**Public Hearing for PUD Amendment – Lot 9,
Southport East Replat Six – Galaxy Ventures, LLC**

RECOMMENDATION REPORT

CASE NUMBER: 2016-PUD-05

RE: PUD Site Plan - Initial Review
Lot 9, Southport East Replat Six

EXISTING CONDITIONS AERIAL IMAGE

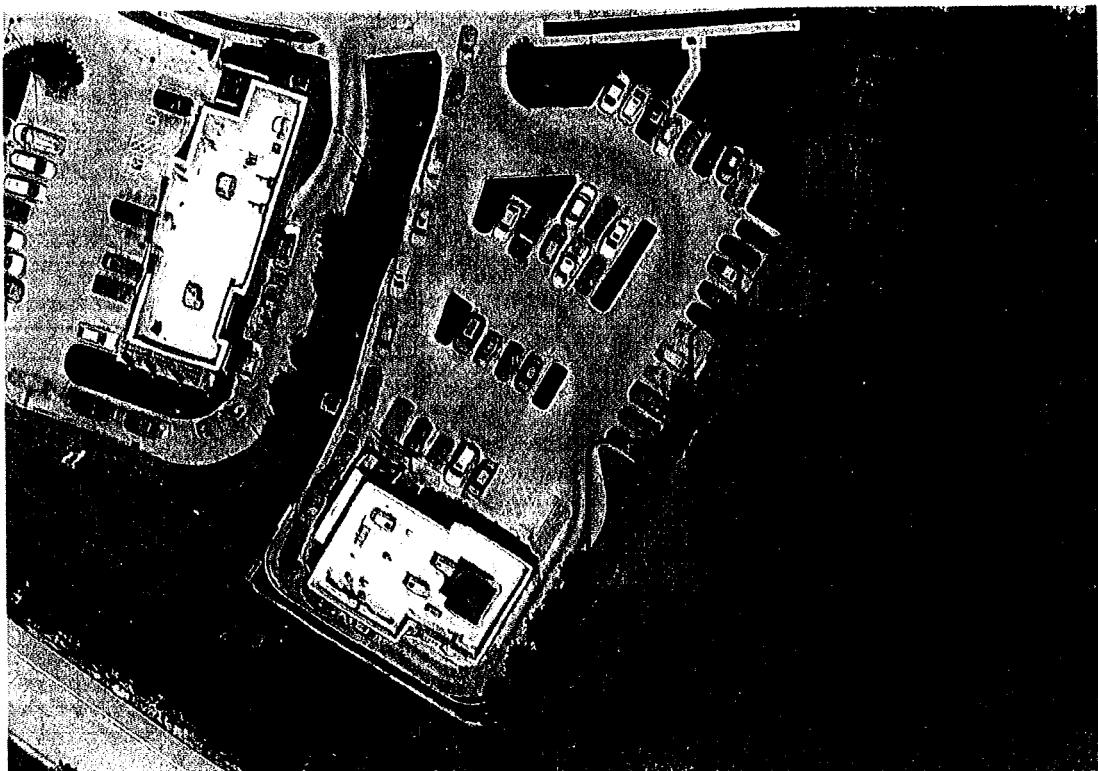
4. The new proposed landscape groupings on the east property do not appear to take in to account the existing plantings previously installed by Runza. The proposed groupings should be adjusted to fill the gaps between Runza's groupings and give adequate distance between existing and new trees. Refer to the existing conditions aerial image below demonstrating how Runza and Burger King handled their adjacent groupings to provide a continuous screened condition, and also highlighting the potential current gaps along the referenced east property line.

1. Comments #1-4 - Plant schedule has been revised to be compliant with Southport East Design Guidelines. Landscape groupings have been revised to coordinate and fill in the gaps of existing plantings previously installed by Runza.
2. Comment #2 - We understand that prior to submission for a building permit, an application for design review approval, through the Southport East Design Guidelines, will need to be submitted.
3. Comment #3 - We understand all light fixtures will need to meet the requirements of the Southport East Design Guidelines.
4. Comment #4 – We understand the design of the monument sign will need to comply with Section 7.01 of the Zoning Ordinance and the Southport East Design Guidelines.

3. Sheet L-1 Landscape Plan

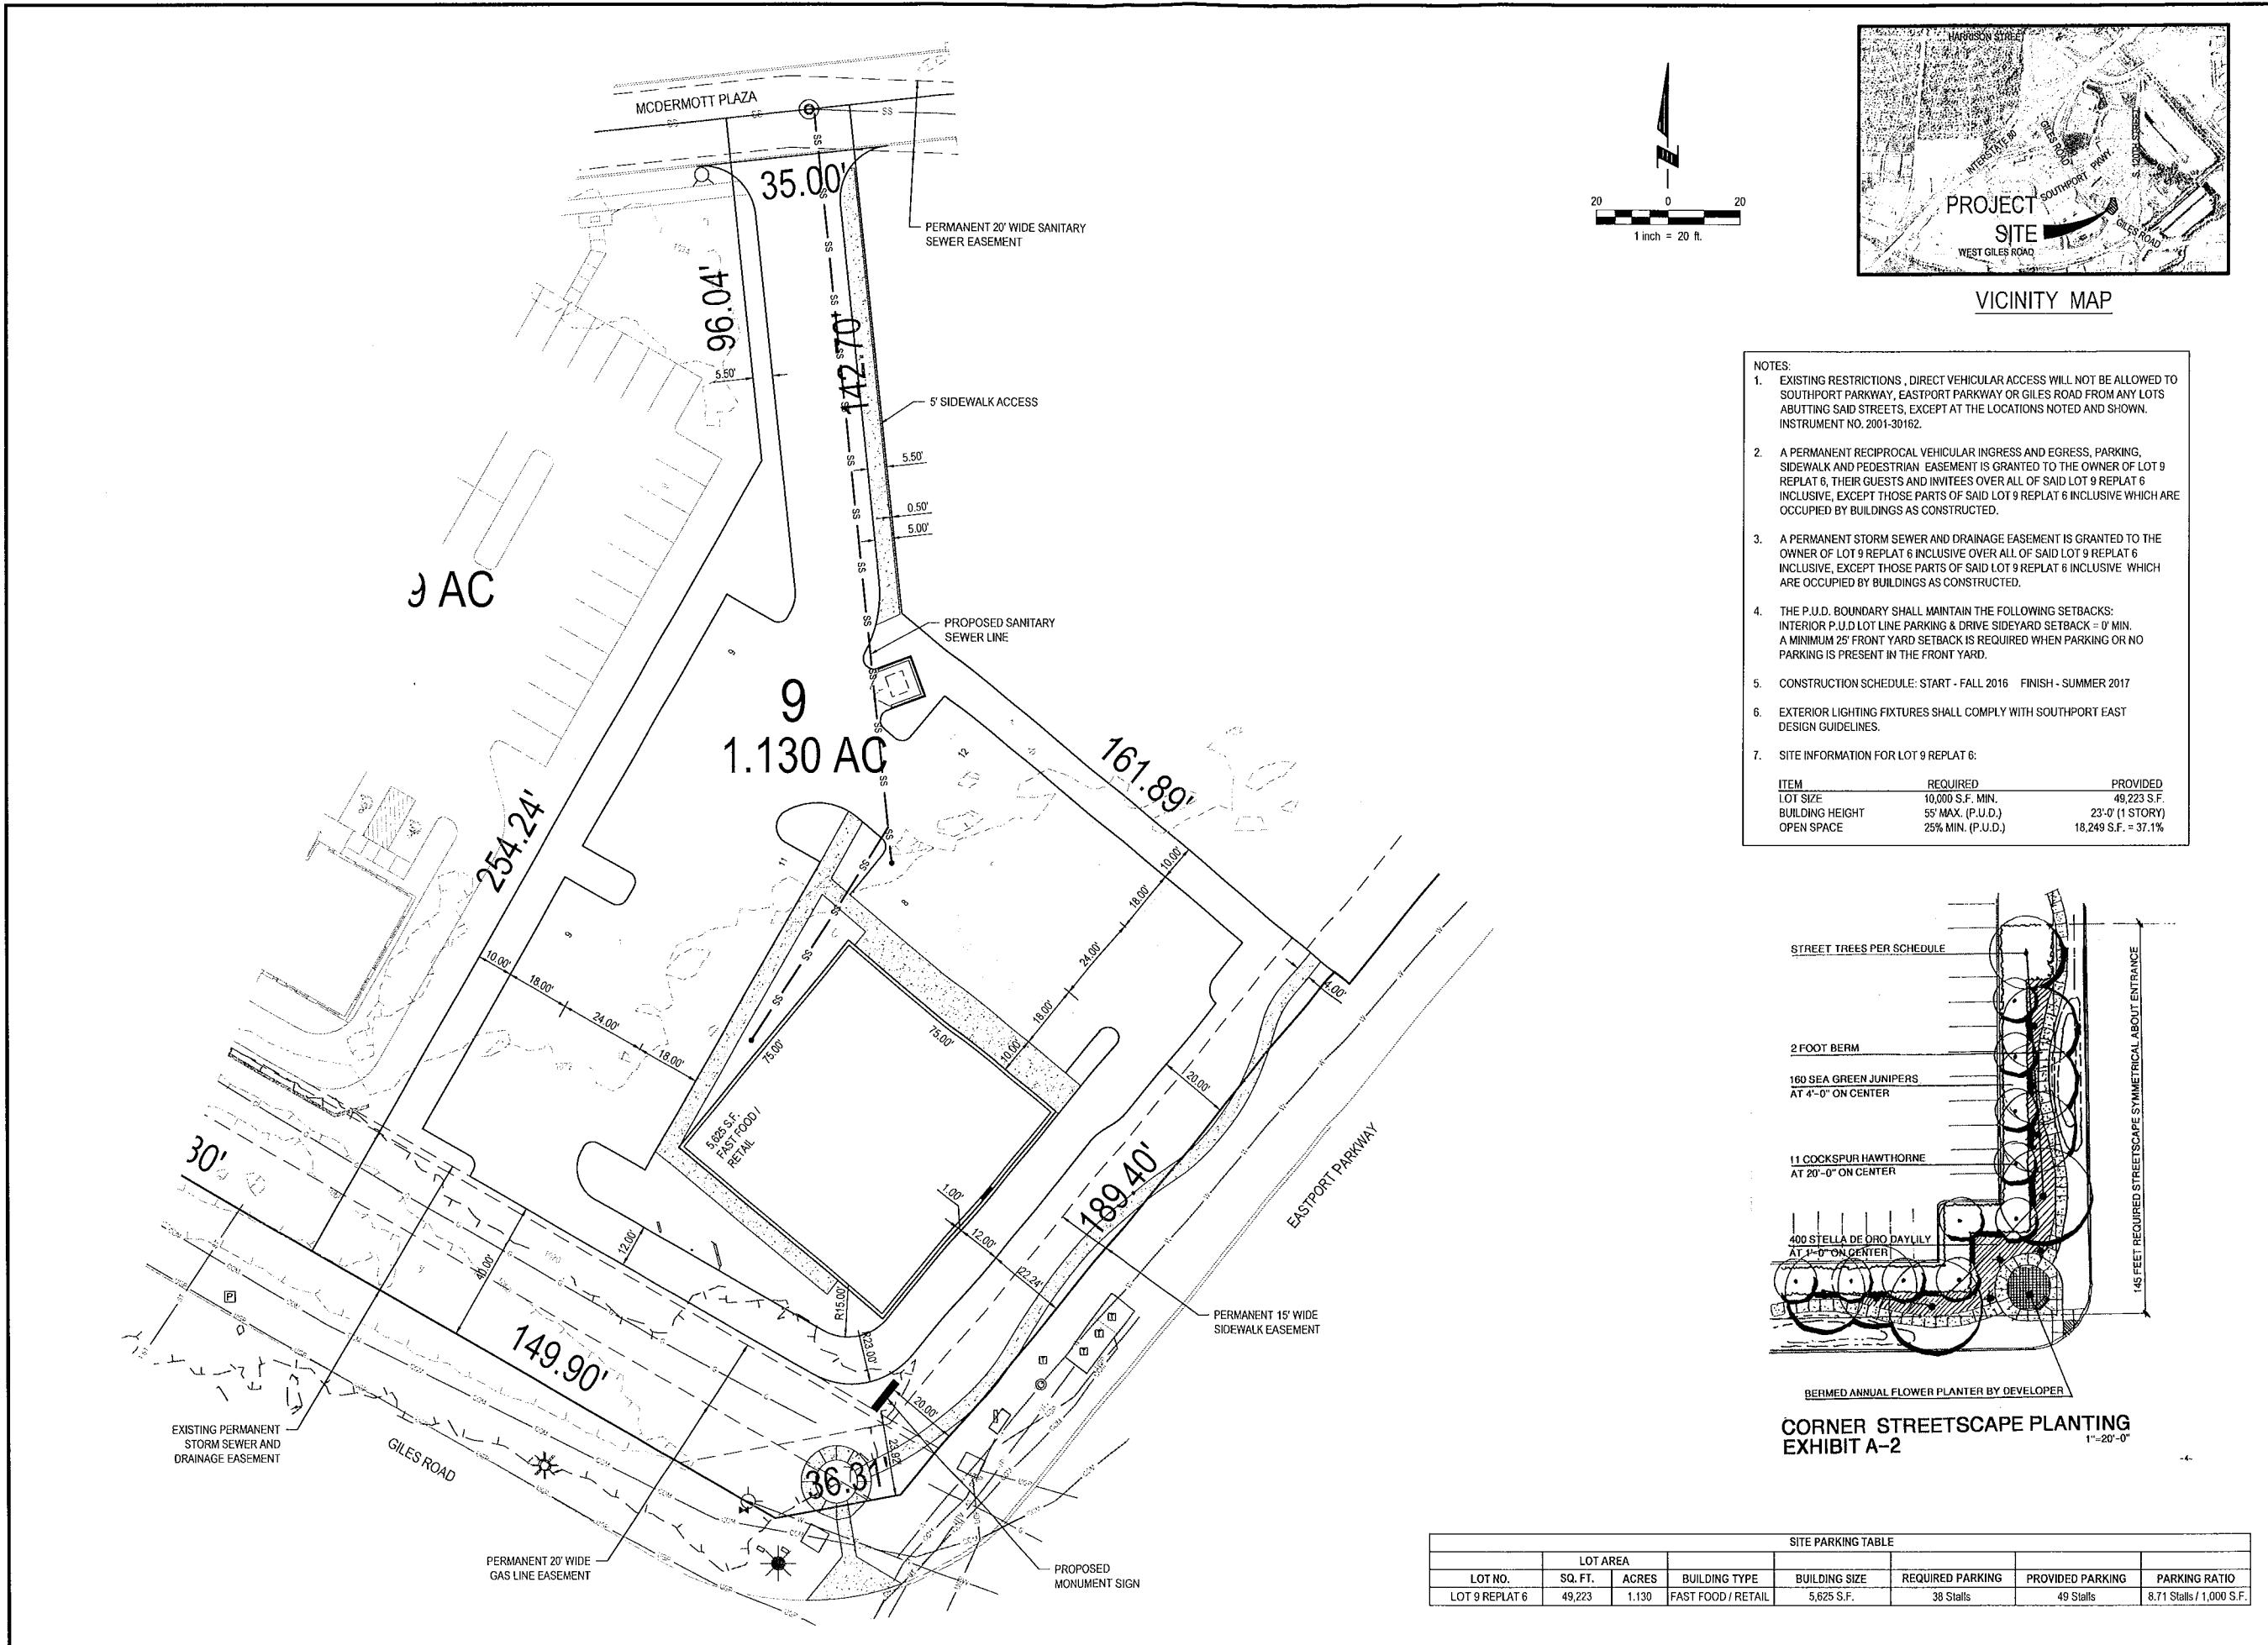
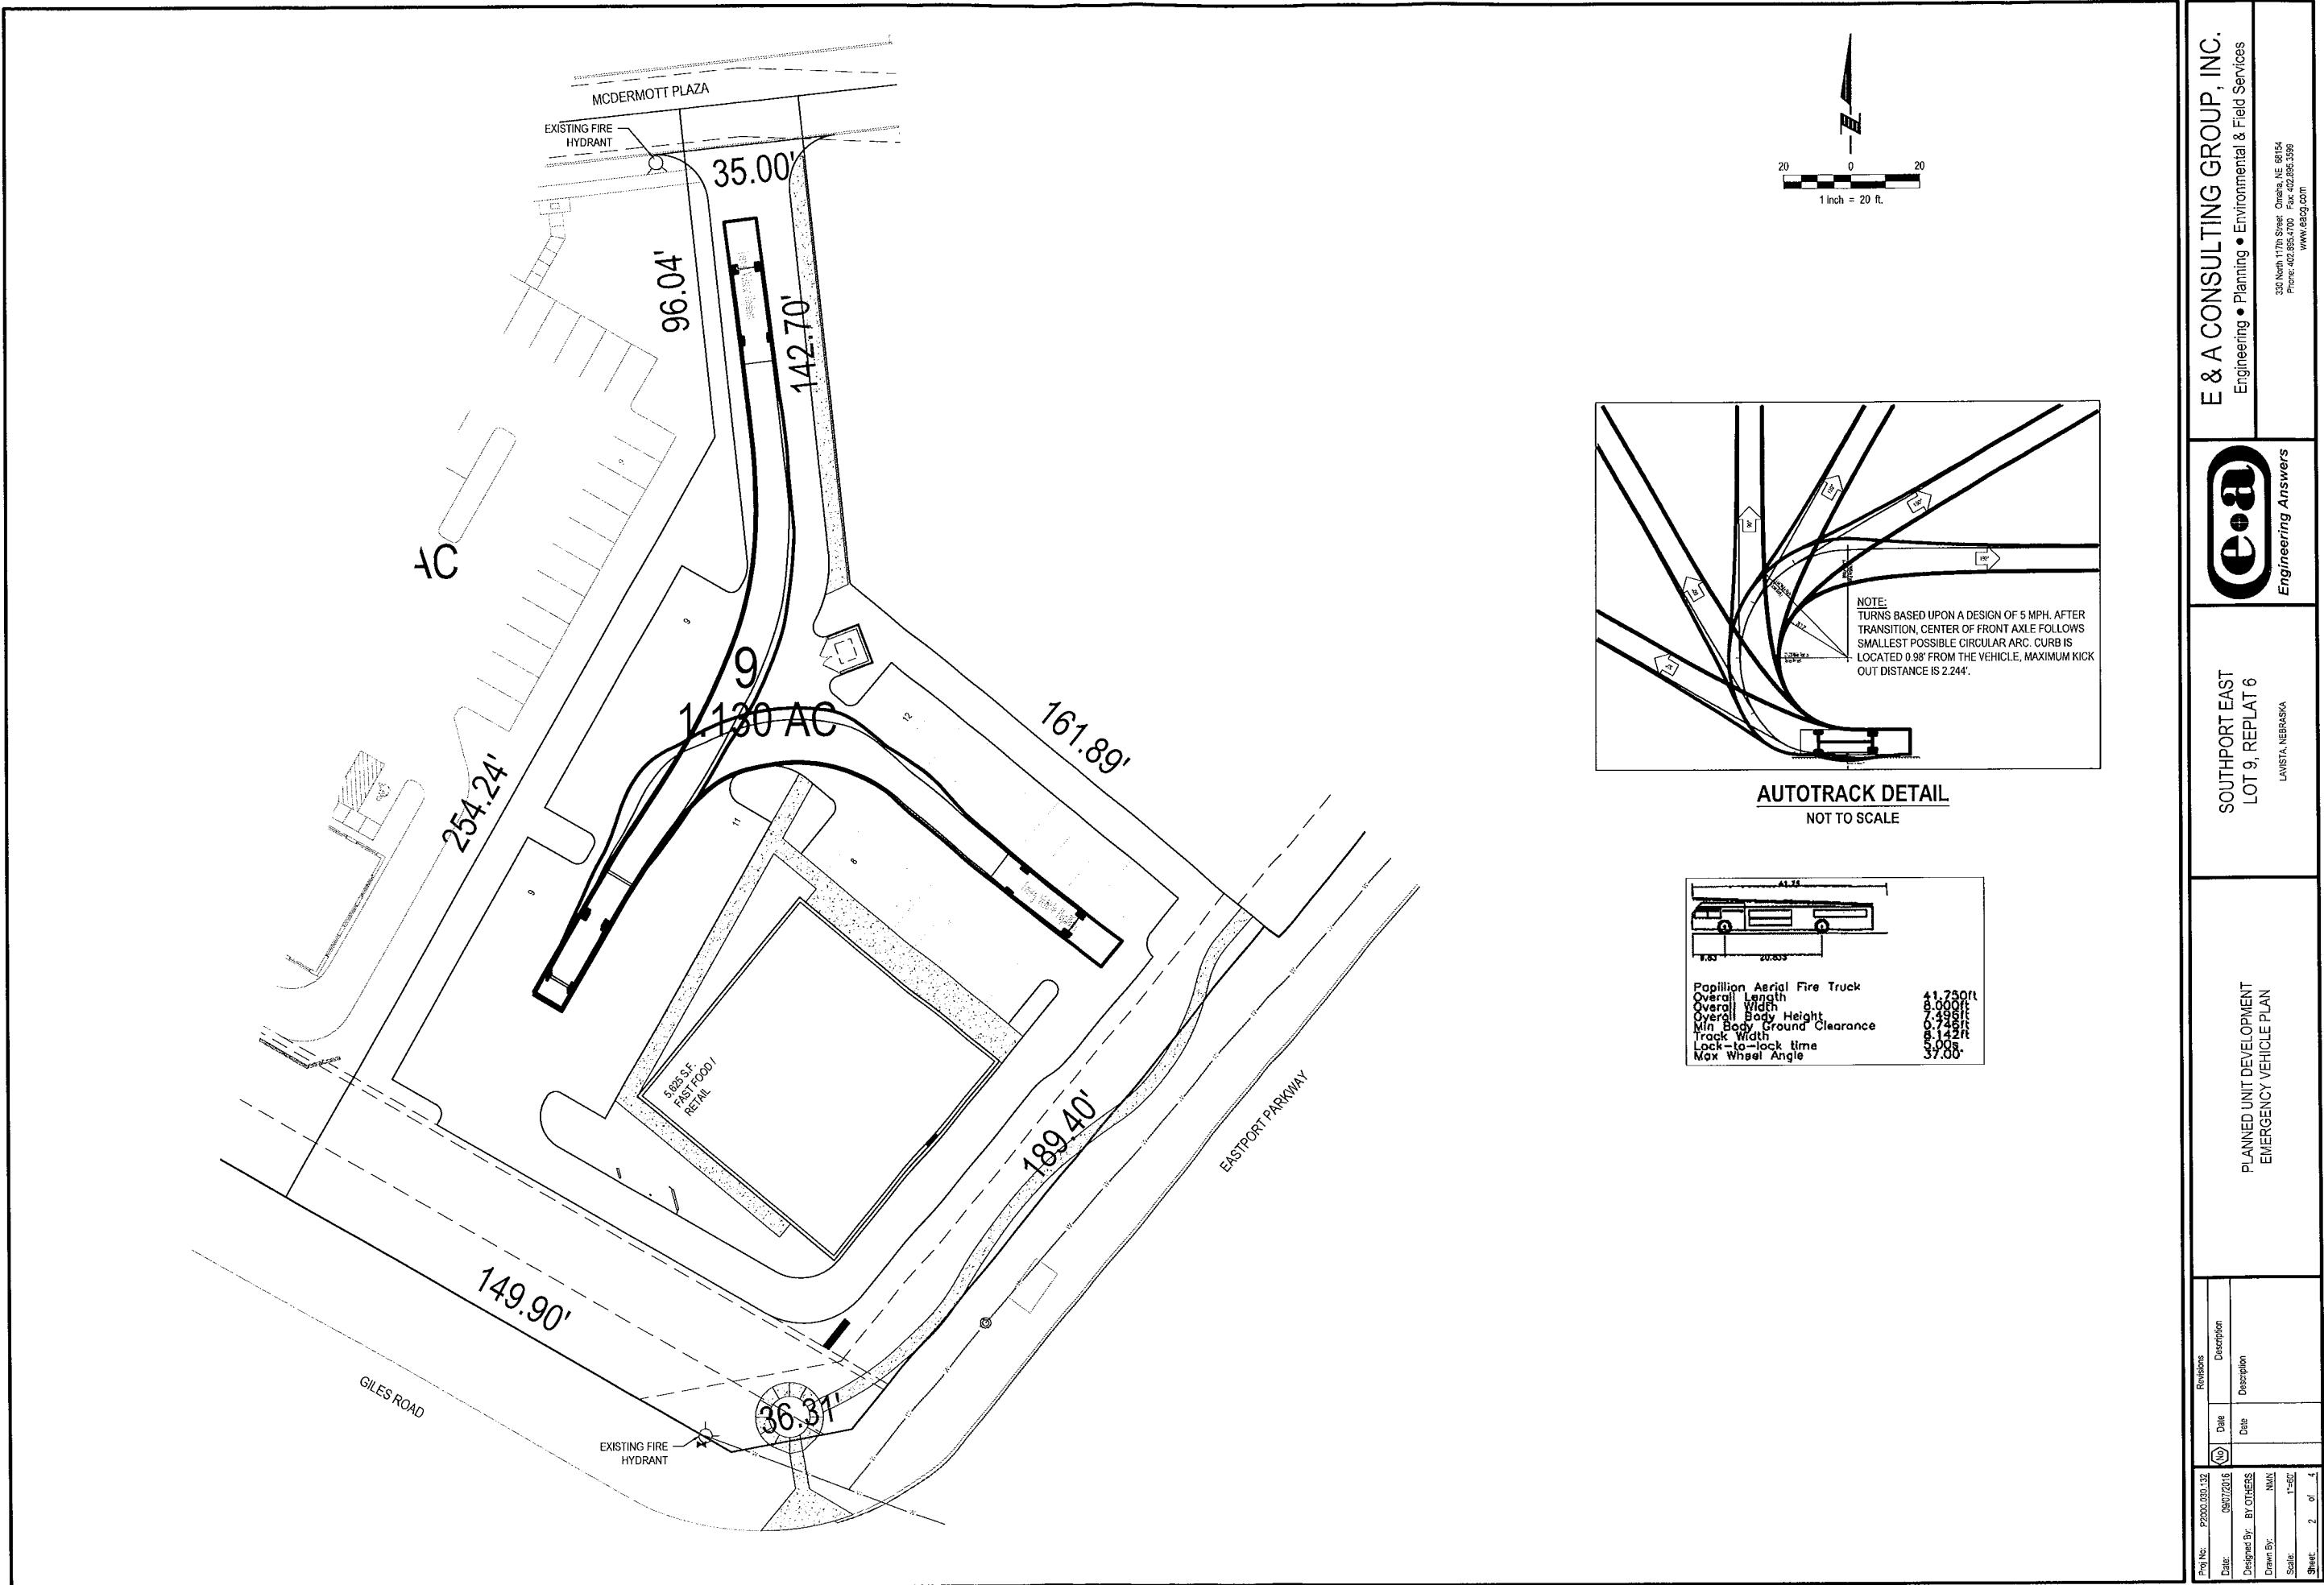
- a. Plant Schedule - Please refer again to the Southport Guidelines, Appendix F and G. for approved Street Tree and Plant Lists. The majority of the proposed selections are non-compliant. Note that we have recently interpreted the Guidelines to allow grasses, even though not included in the required Plant List, to be consistent with what has been previously installed in both Southport East and West. We will allow Sunset Red Maples along Eastport Parkway (old 120th Street) whereas the guidelines call for an Autumn Purple Ash. American National Bank, directly to the southeast, utilized Maples as well so they would match.

- b. The Guidelines don't include Colorado Blue Spruce, although there are existing conifers on the Runza and Burger King sites adjacent to Lot #9. We will allow the spruces because they are screening the view of the trash enclosure from McDermott Plaza, which is desirable.

- c. Plant sizes meet or exceed the minimums. The Sea Green Juniper is 2 gallons to small. The Dense Yew is using a different measurement than the Guidelines (3 Gal v. 18"-24"), which may be similar in size, but needs to be verified.

- d. Please review and resubmit the Landscape Plan with revised selections and designations.

1. Comments #1 – 2 – We have addressed the comments from the City's third-party architect and revised the Landscape Plan. We understand that Design review approval, through the Southport East Design Guidelines, will need to be achieved before building permit submittal.
